STAFF RECOMMENDATION

NCPC File No. 1476

JOHN F. KENNEDY CENTER FOR THE PERFORMING ARTS ACCESS IMPROVEMENTS, PLAZA AND BUILDINGS

May 27, 2004

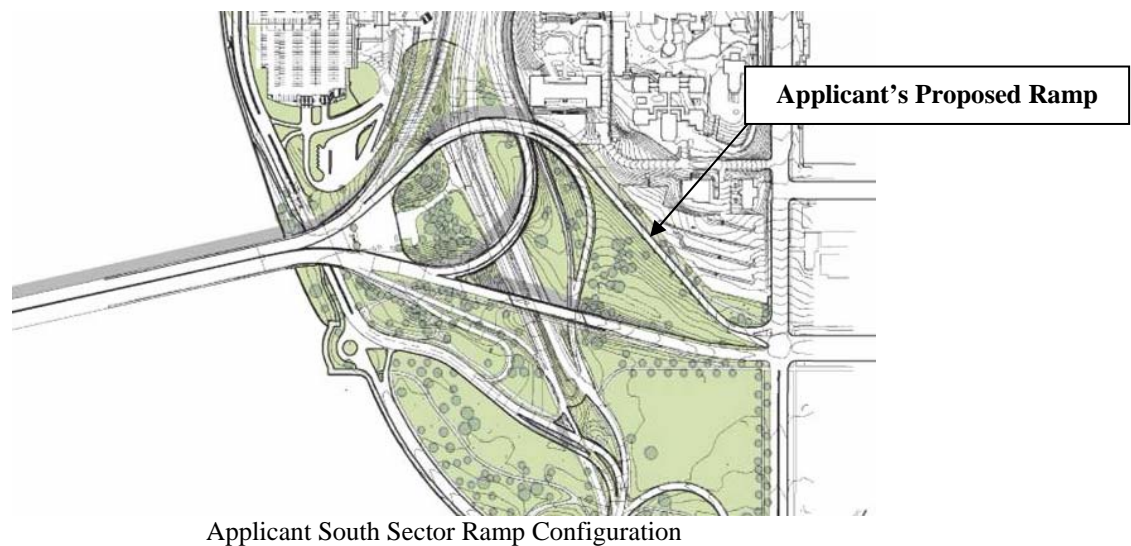
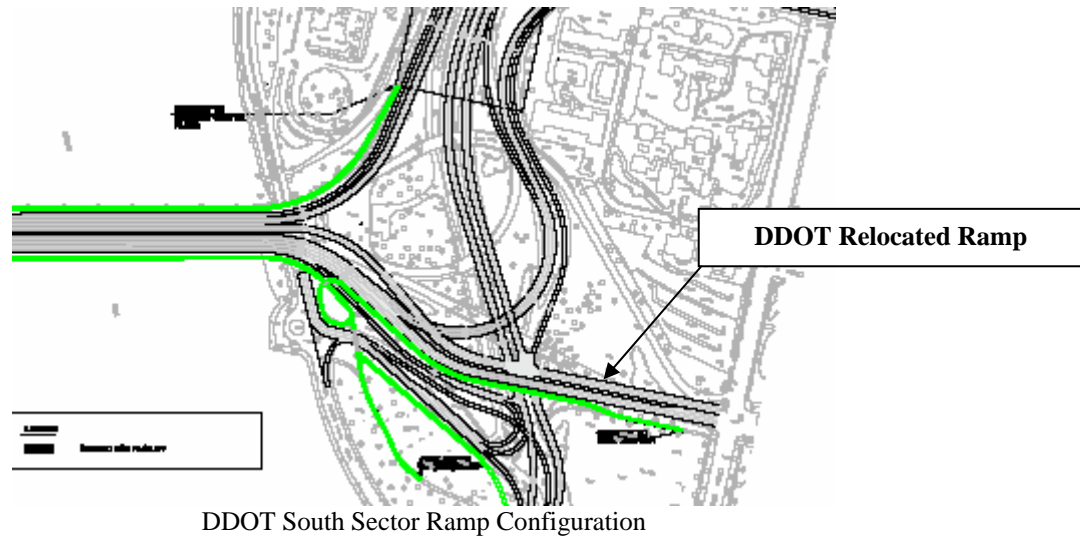
The proposed improvements for the north project sector include the construction of new ramps connecting the Potomac Freeway with 27th Street, NW to replace existing ramps serving the

same function. Staff is troubled by this element of the project. The project goals include relieving congestion at the intersection of Virginia Avenue, NW and the Rock Creek and Potomac Parkway, yet the very ramp connections that are causing this congestion are being retained. The applicant states that these ramp connections are necessary to serve traffic moving between K Street, NW and the Potomac Freeway, and that such traffic will not be able to use the new direct connection between the Rock Creek and Potomac Parkway and the Potomac Freeway. Staff is concerned that retaining the ramps that connect 27th Street, NW to the Potomac Freeway will result in continued traffic congestion on Virginia Avenue and requests that the applicant explore other options to serve the traffic moving between K Street and the Freeway.

- Investigate eliminating the planned on and off ramps between 27th Street, NW and the Potomac Freeway.
- Demonstrate that planned improvements in the north project sector will not preclude re-connectivity of the District street grid in the future, and in particular the potential connection of I Street westward to the waterfront, and the re-establishment of 26th and 27th Streets north of Virginia Avenue, NW.
- Coordinate with the District Department of Transportation in the north project sector to ensure design compatibility with changes to the Whitehurst Freeway currently under study.

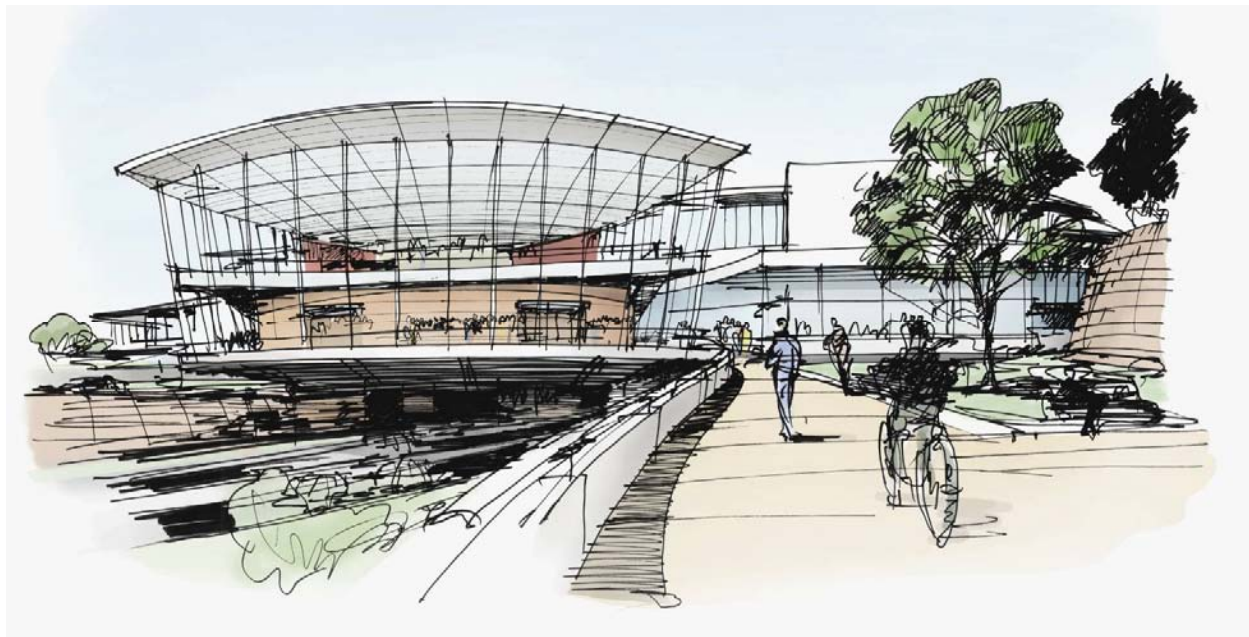
While the proposed project accommodates a bus stop to serve Metrobus, the submission does depict a route for the Kennedy Center shuttle. Additionally, the project should indicate how the project site can accommodate the District Department of Transportation's plans for a future light rail system in the District of Columbia. Finally, the project design should include specific pedestrian improvements in the area between the Foggy Bottom Metro station and the Center to encourage more visitors and patrons to arrive at the Center by Metrorail.

Proposed Bicycle Trail between 23rd Street, NW and Kennedy Center Plaza

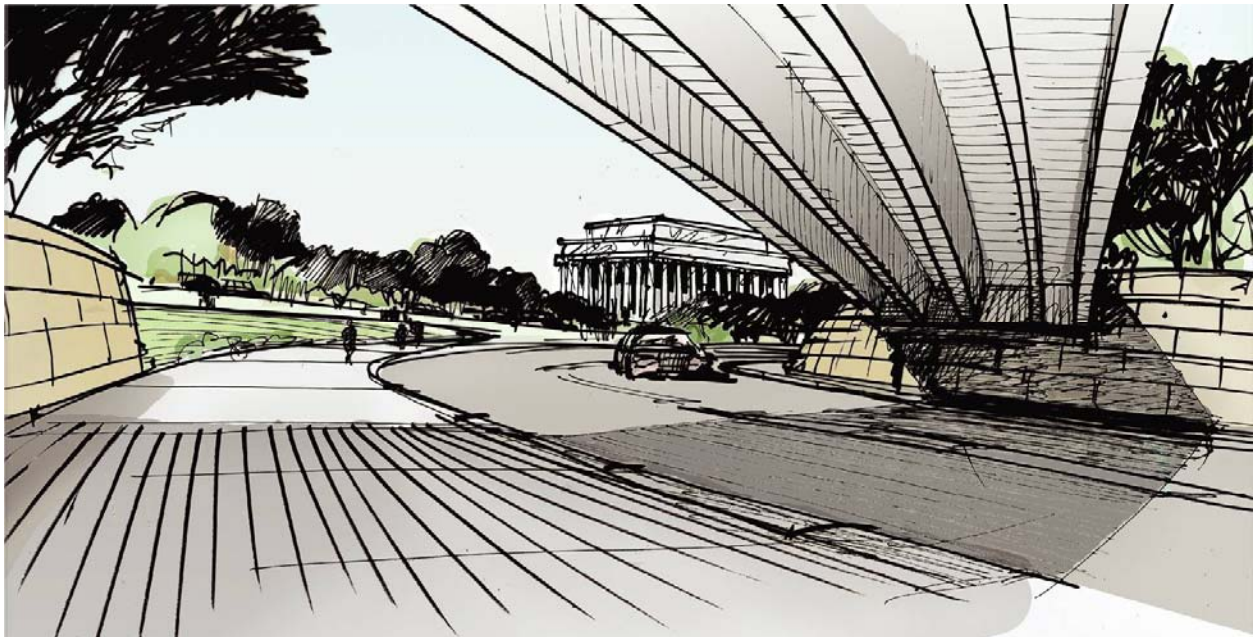
The project's design, in addition to improving conditions for automobile movement, takes significant strides toward completing the bicycle trail network within its environs. Currently, the area around the Center impedes the through movement of cyclists, with disconnects in the trail and dangerous roadway crossings. The proposed project will reconnect the trail system at several key areas. The first is the intersection of Ohio Drive, NW with the Rock Creek and Potomac Parkway and the Potomac Freeway where a grade separation will allow unimpeded bike movement. The second is in the vicinity of 23rd Street, where a new trail connection will be constructed along the south side of the Naval Observatory. The third is at the landing of the

Roosevelt Bridge, where cyclists can connect from the bridge itself to the plaza and the west end of the National Mall. Finally, the project will connect bike movements through the development site itself, both at the water's edge and by artfully weaving new trails directly into and through the proposed new buildings and their public plaza. Staff is encouraged by the extent of planned bicycle trail connections in the proposed project, but cautions that project budget constraints should not result in the elimination of bicycle improvements from the project scope. Additionally, staff recommends that bicycle parking facilities at the Kennedy Center be accommodated in the design. Finally, staff recommends that the bicycle trail shown between the Naval Observatory and the new south building of the Kennedy Center be carefully designed with maximum visibility through the site so that it does not become a public safety hazard.
